## Proposal for Amendment 2 to the Consolidated Resolution on the common specification of light source categories (R.E.5)

## Amendment 2 to the Consolidated Resolution on the common specification of light source categories (R.E.5)

[3]	[2018-xx-xx]	[174]	[ECE/TRANS/WP.29/2018/xx]	Introduction of new light emitting diode (LED) forward lighting light source categories L1A/6 and L1B/6 as a package with Supplement [7] to Regulation No.128
-----	--------------	-------	---------------------------	---

Main Drawing, L1A/6

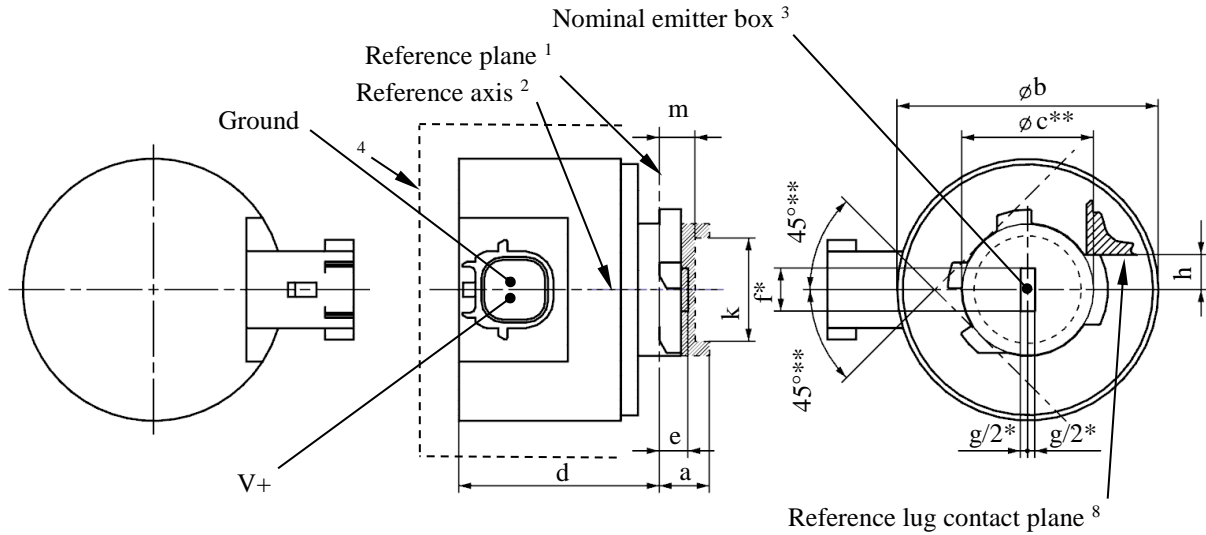
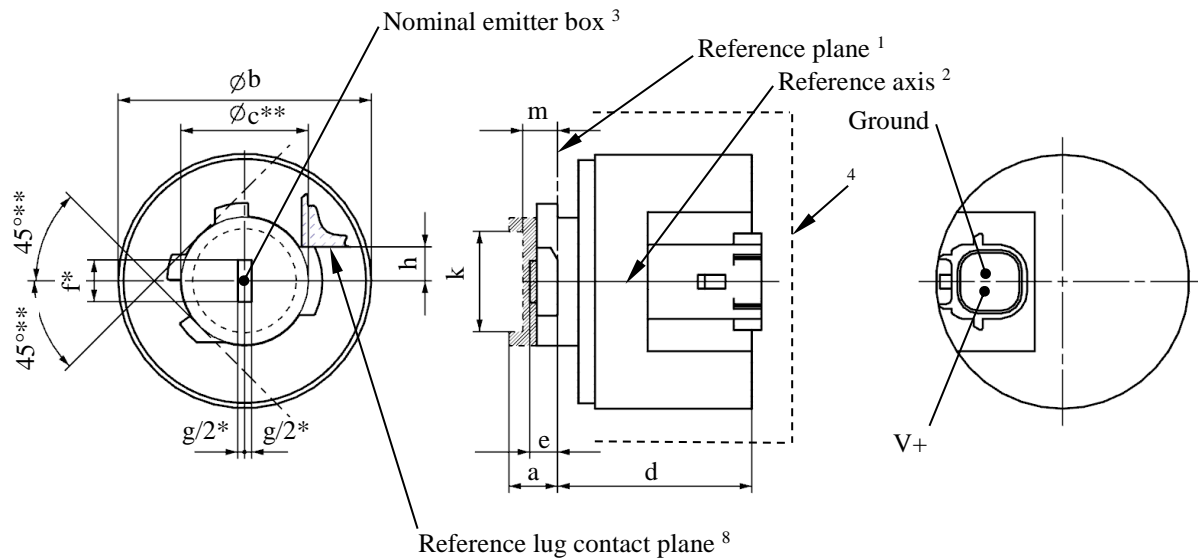
*Before sheet LR1/1, insert new sheets L1/1 to 5, to read (see the following pages; one page per sheet):*

**Definition of the nominal emitter box with dimensions as specified in table 2**

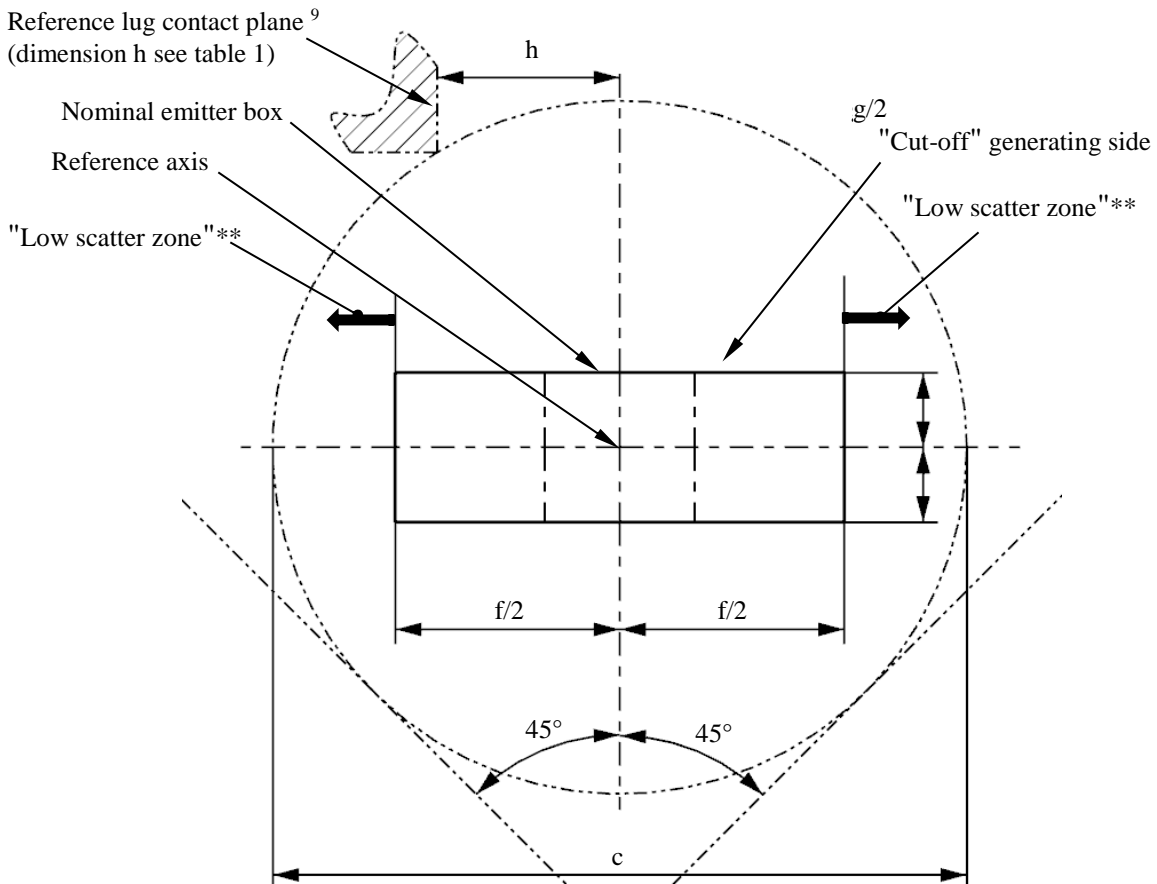
The position, the contrast and the uniformity of the light emitting area are checked by the nominal emitter box system defined in figure 3, which shows the projection when viewing along direction of the reference axis ( $\text{Gamma} = 0^\circ$ ) as defined in Figure 4.

Dimensions	f	g	
	mm	4.0	1.4
Number of equidistant subdivision to control deviation of luminance	3	2

\*\* The value of the maximum luminance in the "low scatter zone" expressed as a percentage of the average luminance of the light emitting area shall be not higher than 10 per cent.

**Set-up to measure the luminous intensity distribution for L1A/6**

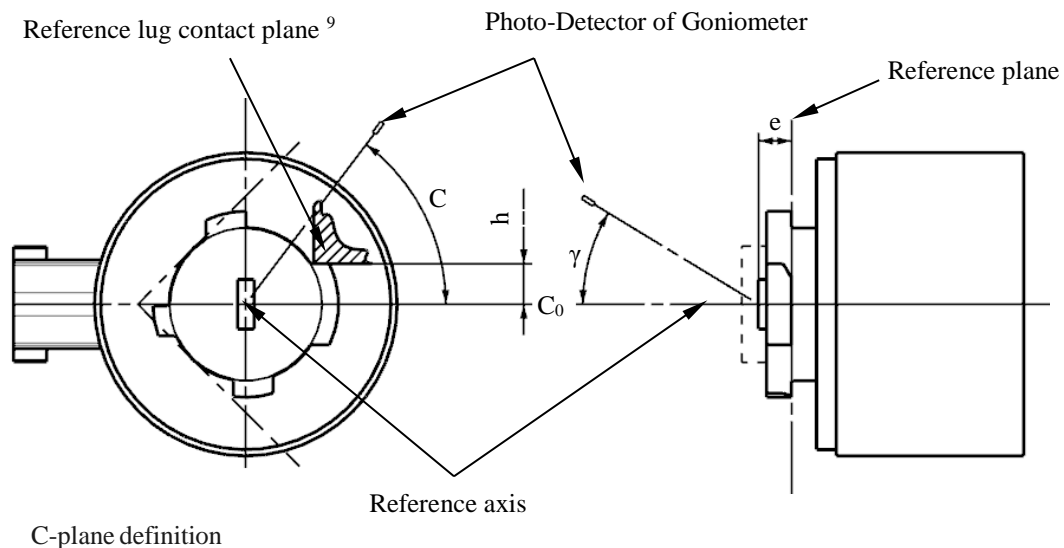
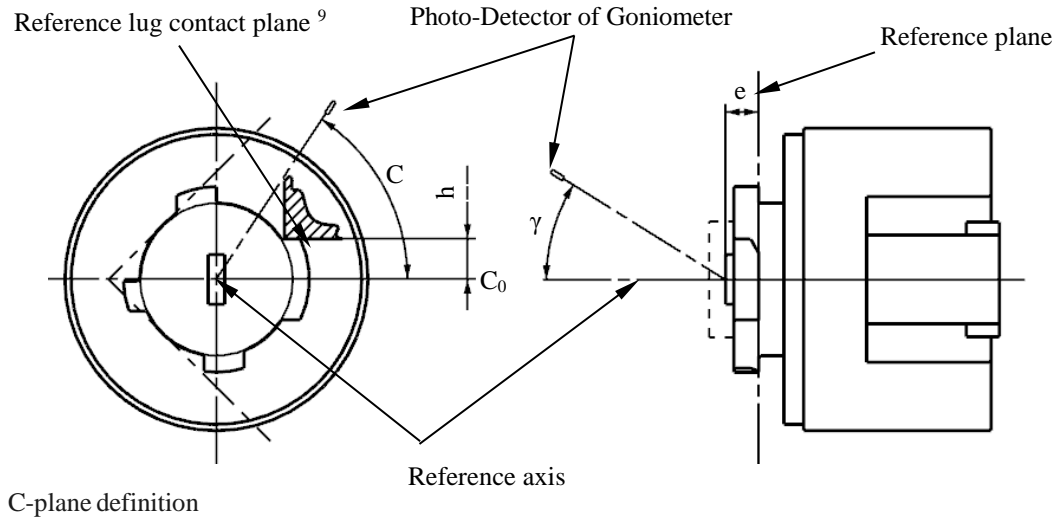
The light source is mounted on a flat plate with the corresponding mounting lug features. The plate is mounted to the goniometer table by a bracket, so that the reference axis of the light set-up is described in Figure 4.

The measurements shall be performed in C-planes  $C_0$ ,  $C_{90}$ ,  $C_{180}$  and  $C_{270}$ , which contain the reference axis of the light source. The test points for each plane for multiple polar angles  $\gamma$  are specified in Table 3.

After measurement the data shall be normalized to 1000 lm according to Paragraph 3.1.11 using the luminous flux of the individual light source under test. The data shall comply with the tolerance band as defined in Table 3.
